**DEVIATION REQUEST
AND DECISION FORM**

Project Name : Skyline at Lorson Ranch
 Schedule No.(s) : 5500000440, 5500000274, 5500000275, 5513300005, 5513310105
 Legal Description : See Attached

A deviation from the standards of or in Section 2.2.5 (E) of the Engineering Criteria Manual (ECM) is requested.

**DEVIATION 1
 EXHIBIT**

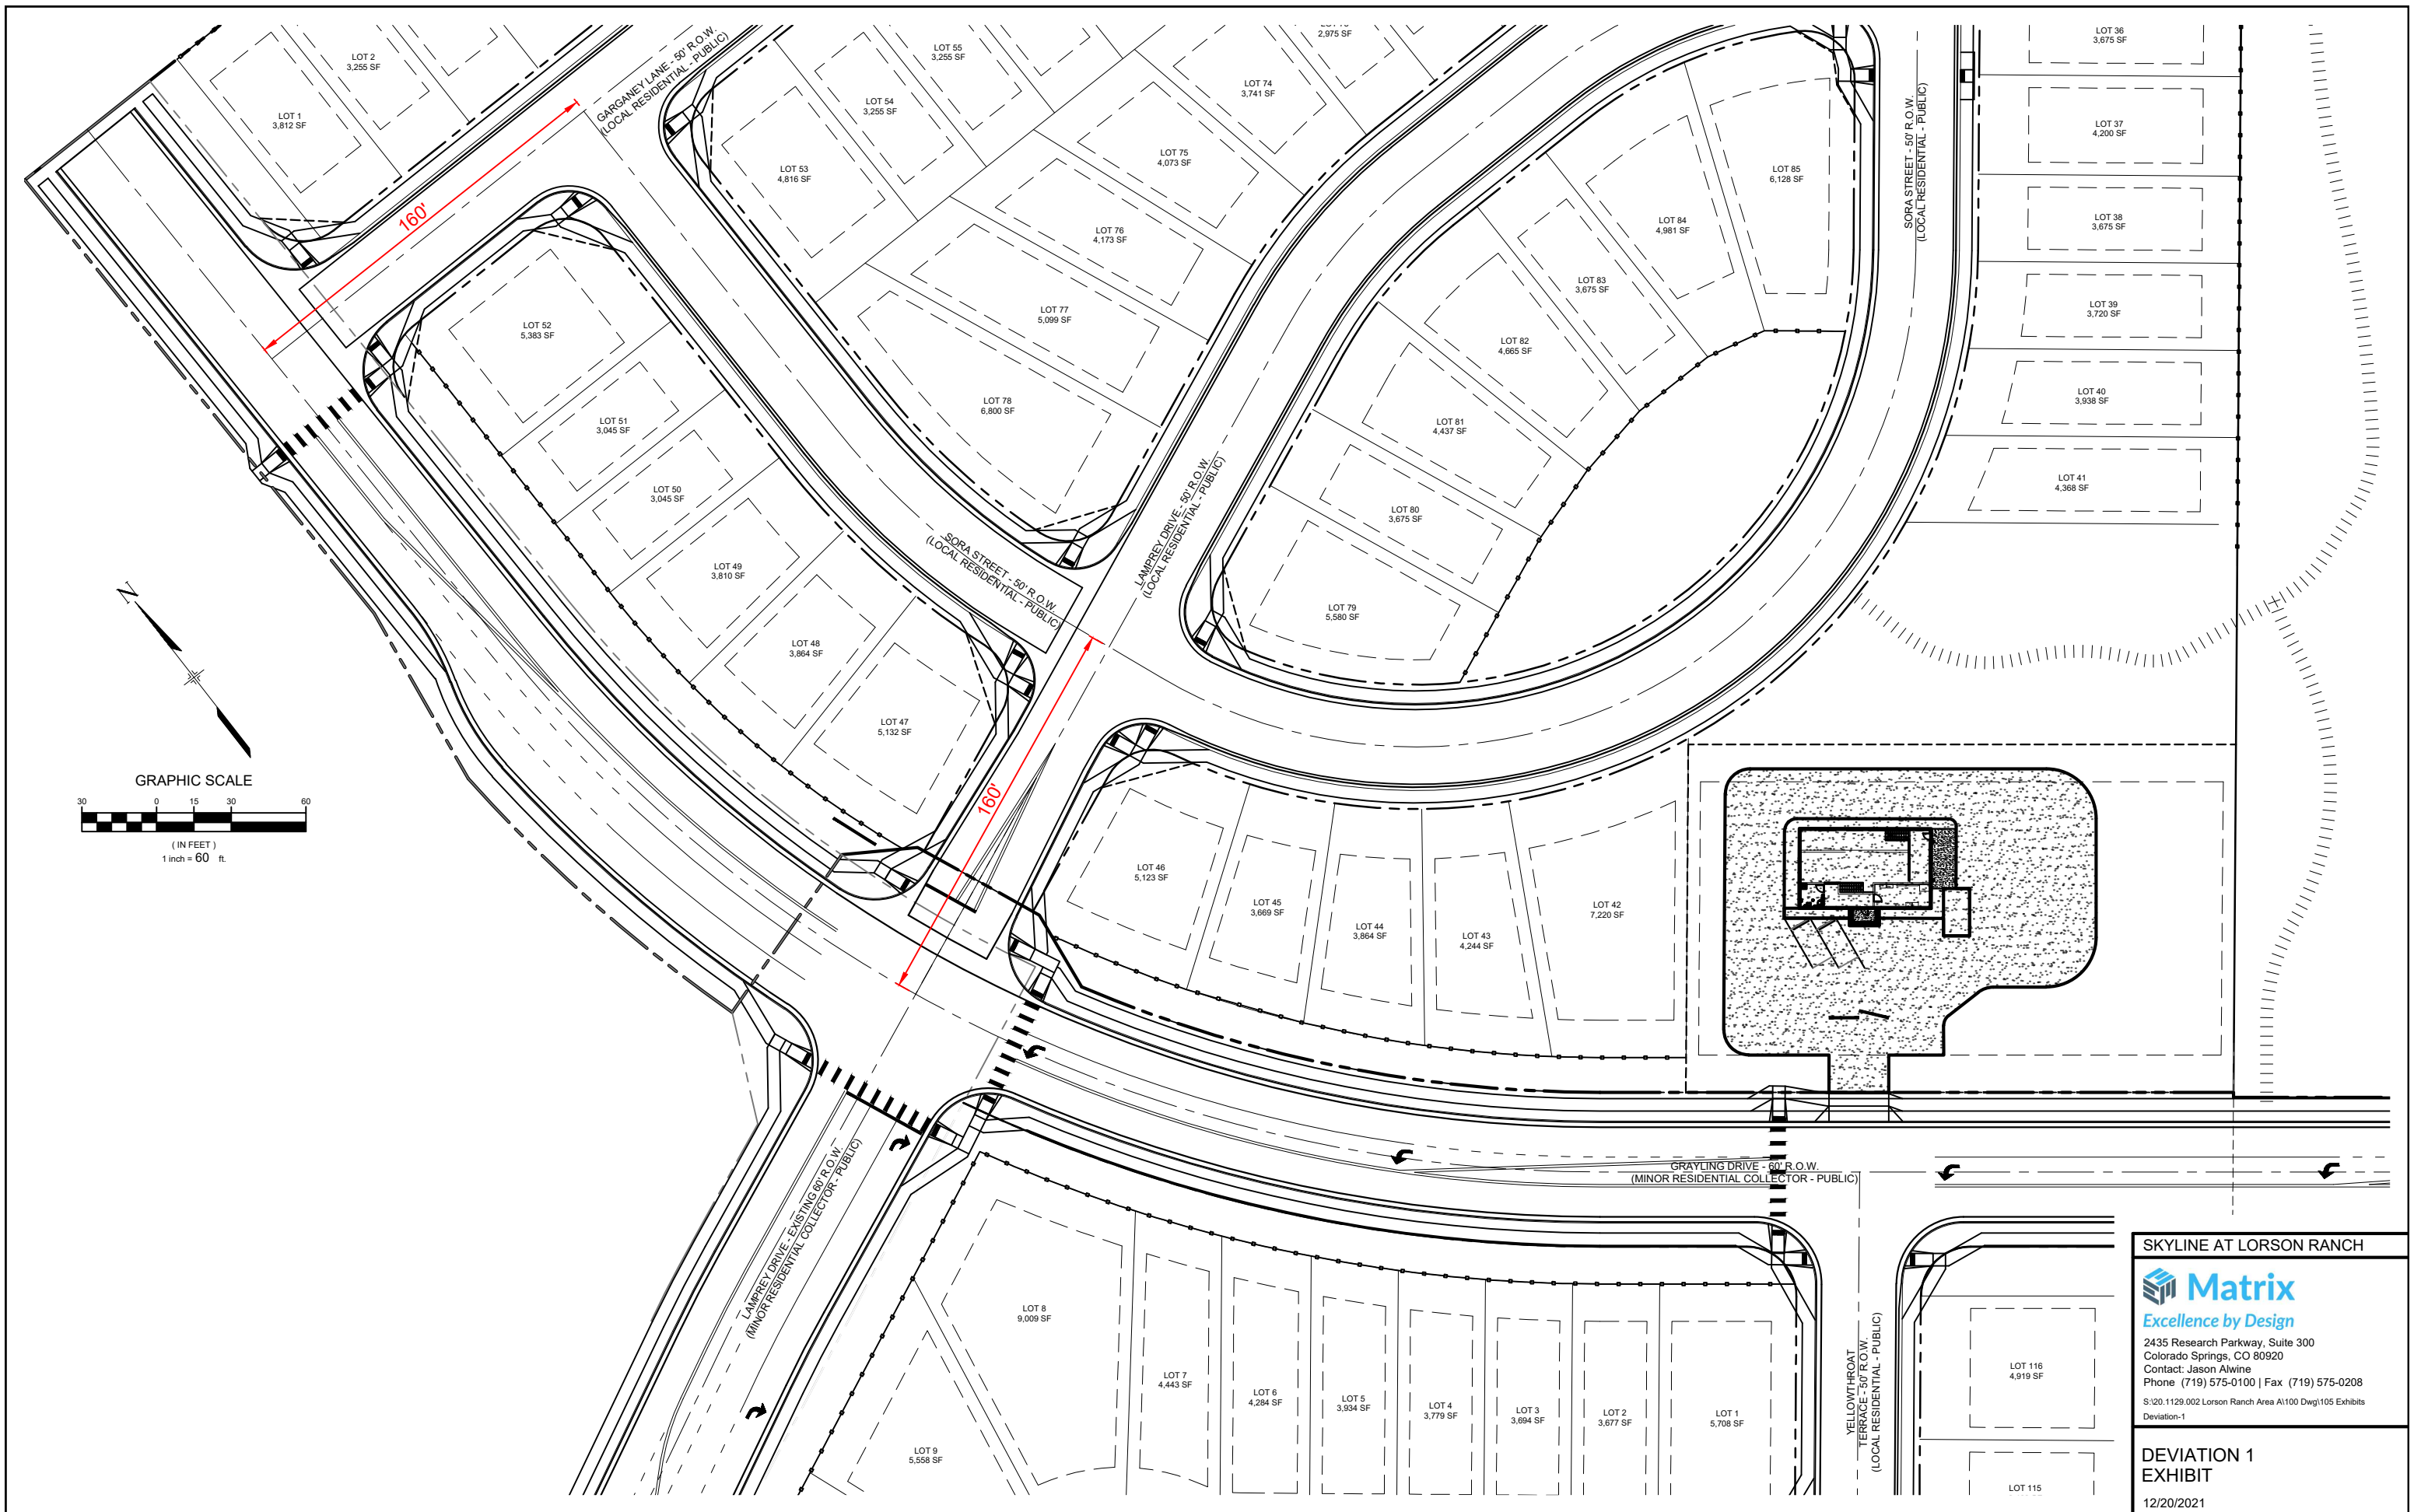
This should be 200' for spacing from collectors. Describe what the other design options would be and why they wouldn't work (longer lots or a tract behind the lots).

Maybe address the anticipated future function of Grayling (level of traffic and speeds, etc.)

Address sight and stopping distances with the reduced lengths, and conflicting traffic movements (driveways)

Will this add more road surfaces proportionally compared to if the spacing was met? or can the same number of roads (or lane miles) be constructed if spacing was per criteria? for example, if you consistently do this over a large area, you could have more lane miles, thus adding to the cost of maintenance. Please add additional support to this section.

Just stating that it doesn't is not adequate. Please elaborate. For example, 160' vs 175' would look the same to a person at the intersection, there are not added roads or multiple of these shortened intersections in a row to appear as if there a an excess of intersections.
